# UNITED STATES PATENT AND TRADEMARK OFFICE

APPLICATION NO.	FILING DATE	FIRST NAMED INVENTOR	ATTORNEY DOCKET NO.	CONFIRMATION NO.
10/825,962	04/16/2004	Aaron D. Markworth	17116-003001	8210
26181 7590 06/22/2007 FISH & RICHARDSON P.C. PO BOX 1022 MINNEAPOLIS, MN 55440-1022				
			EXAMINER ARAJ, MICHAEL J	
			ART UNIT 3733	PAPER NUMBER
			MAIL DATE 06/22/2007	DELIVERY MODE PAPER

**Office Action Summary**

## **DETAILED ACTION**

**Figure 1 (Taken from '957)**

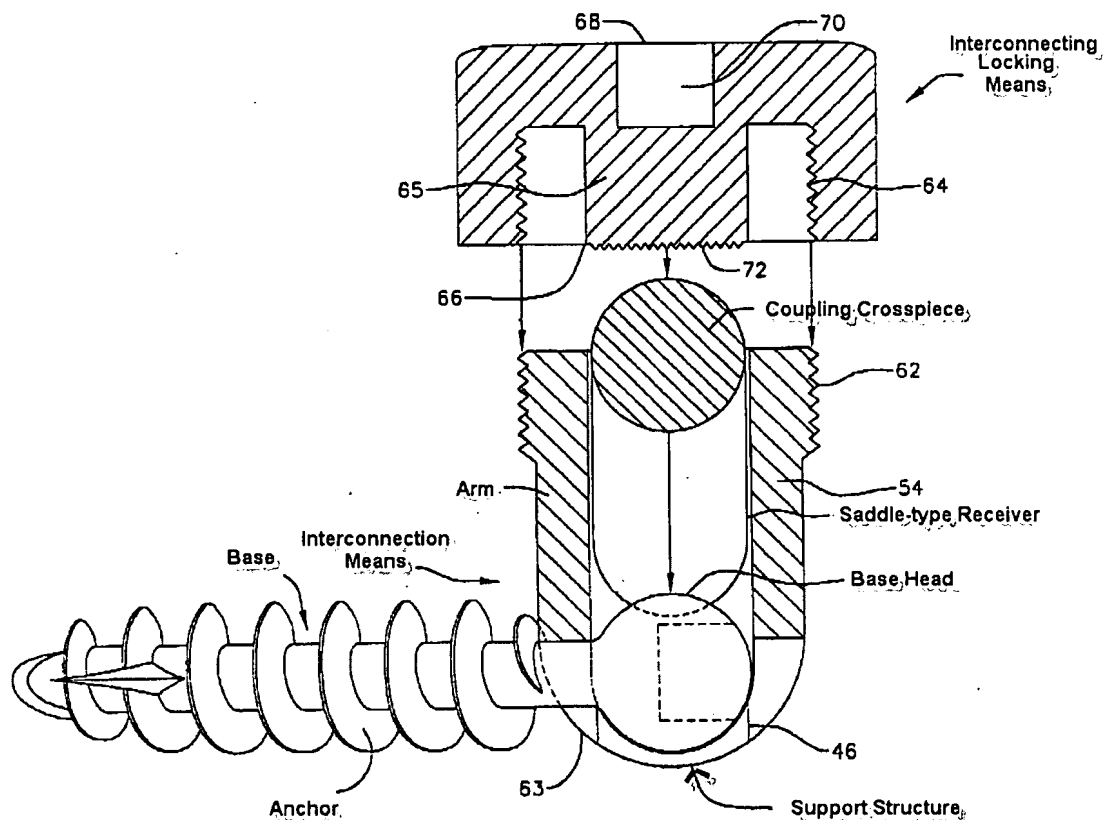
Claims 1-6, 10-23 and 40-44 are rejected, as understood, under 35 U.S.C. 102(b) as being anticipated by McKinley (U.S. Publication No. 2003/0032957). McKinley discloses a medical device comprising a screw assembly including a base (comprised of a base head and bone screw anchor), a rod-shaped arm and an interconnection means. The interconnection means allows the arm to be positionable in a first position that is parallel to a long axis of the base and positionable in a second position that is perpendicular to the long axis of the base. The base is configured for

attachment to a structure in a patient that is bone, and the arm is configured for attachment to a support structure. (See Figure 1 below) A second screw assembly is considered to be the interconnecting locking means designated in Figure 1 below, which can also be considered a cam or set screw by their respective definitions. The overall length of the device is substantially between .1 and 100 centimeters and 50-600 millimeters that is sized for subcutaneous support of the posterior of a spine. Each side of the receiver is considered to be an opening leaving the interpretation of a plurality of openings in the receiver.
